May 6, 2022

RE: Docket Number EERE-2019-BT-STD-0040: Energy Conservation Standards for Ceiling Fan Light Kits

Figure 1: MAEDbs CFLK model efficacy (blue dots), the current DOE minimum standard (black line) and the evaluated max-tech level (red line) vs. CFLK lumen output.

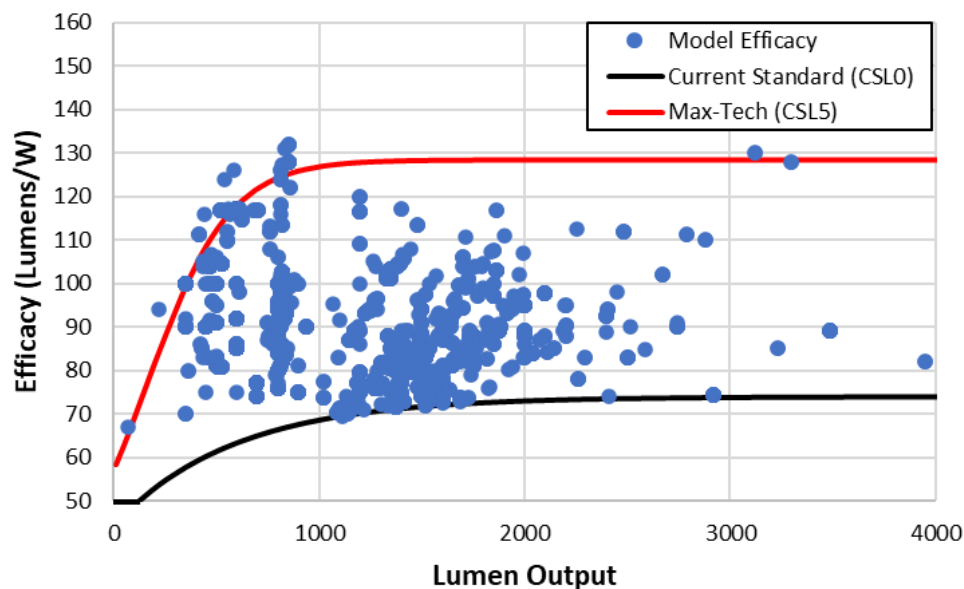
However, it is unclear whether the CSLs evaluated in the PTSD appropriately reflect CFLK efficacy as a function of lumen output. Figure 1 plots CFLK efficacy versus lumen output for CFLK models in the CEC Modernized Appliance Efficiency Database System (MAEDbs)⁷ along with the current standard (CSL0) and the evaluated maximum technologically feasible (max-tech) CSL5 level. There are multiple models at lower lumen outputs that exceed the max-tech level. In particular, there are several models at approximately 850 lumens, near the representative LED lamp outputs of 800-810 lumens in DOE’s

analysis, that have similar efficacy (130 lm/W) as a model at 3100 lumens. Overall, these results suggest that the higher CSLs evaluated in the PTSD may be easier to meet at lower lumen outputs. Thus, we encourage DOE to further investigate the relationship between efficacy and lumen output.
